DEPARTMENT OF TRANSPORTATION

National Highway Traffic Safety Administration

Child Restraint Systems; Anthropomorphic Test Devices; Hybrid III Six-Year-Old Weighted Child Test Dummy

ACTION: Final rule, technical amendment.

FIGURE S1
THORAX IMPACT TEST SET-UP SPECIFICATIONS

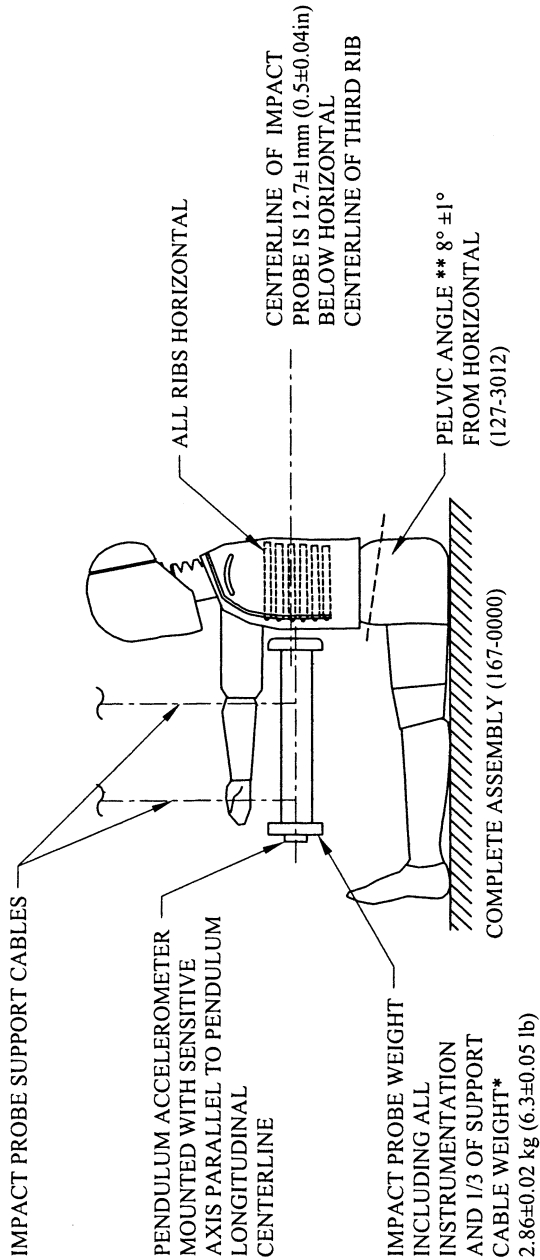
Second, with regard to the thorax assembly and test procedure specifications for the HIII-6C dummy (49 CFR 572.124(b)(1)), the peak force defining the compression corridor was proposed to be changed from 1150–1380 Newtons (N) (259–310 lbf) for the HIII-6C dummy to 1225–1455 N (275–327 lbf) for the HIII-6CW (weighted) dummy. This was in response to test

Issue No. 2 (Thorax impact test): In developing the NPRM, the agency performed seven thorax impacts with a single weighted dummy. In these tests, the peak pendulum force responses in the dummy’s thoracic deflection range of 38–46 mm met the specifications for the HIII-6C dummy in all tests. However, the average response was close to the upper limit of the specified corridor. In response to these results, the agency proposed changing the corridor from 1150–1380 N (for the unmodified HIII-6C dummy) to 1225–1455 N for the HIII-6CW dummy. The shift in the corridor was to assure better centering of the response specification.

Denton commented that the agency evaluation of the HIII-6CW dummy was insufficient to justify proposing a corridor different from those in the thorax impact test required for the unmodified HIII-6C. Denton was concerned that only a single dummy was tested to develop a new corridor. Denton suggested that either the agency

The commenter submitted data from seven tests that it performed on a single dummy with and without the weights.⁶ According to Denton's data, both the HIII-6CW (weighted) dummy and the HIII-6C dummy passed the 49 CFR Part 572 subpart N requirements. Denton's data from the weighted dummy demonstrated a slight difference in performance as compared to the unmodified dummy, but Denton stated that this was insignificant in relation to the corridor. Further, the weighted dummy tested by Denton performed close to the lower margin of the proposed corridor.

With regards to the thorax impact test, Denton supplied the agency with three more thorax impact tests performed on a weighted dummy.⁷ The dummy tested by Denton fit within the thorax corridors proposed by the agency, although with slightly lower values than generated by the agency's testing. Based on the results of Denton's thorax impact tests, the agency was able to generate a larger sample size to evaluate the HIII-6CW dummy.

The average of the pooled sample still results in a corridor higher than that used for the HIII-6C dummy, but lower than that originally proposed for the weighted dummy. Based on the average of the larger sample size, the agency is adopting a peak pendulum force corridor of 1205–1435 N (270.9–322.6 lbf) during the maximum allowed deflection range of 38 to 46 mm.

Response: The agency agrees that the current upper limit of 1500 N has eliminated the need to permit a 10 percent exceedance during the thoracic deflection range of 12.5–38 mm. Subsequent to the development of the HIII-6CW (weighted) dummy technical report, the agency increased the peak force limit for the sternum displacement test to 1500 N (67 FR 47321; July 18, 2002). All of the data submitted by Denton and generated by the agency for the sternum displacement test was below the 1500 N maximum, demonstrating that the increased maximum limit of 1500 N is valid for the HIII-6CW dummy as well as for the un-weighted dummy. Further, adoption of this maximum maintains consistency with HIII-6C dummy specifications.

(b) When the anterior surface of the thorax of a completely assembled dummy (drawing 167–2000) that is seated as shown in Figure S1 is impacted by a test probe conforming to 49 CFR 572.127(a) at 6.71 ± 0.12 m/s (22.0 ± 0.4 ft/s) according to the test procedure specified in 49 CFR 572.124(c):
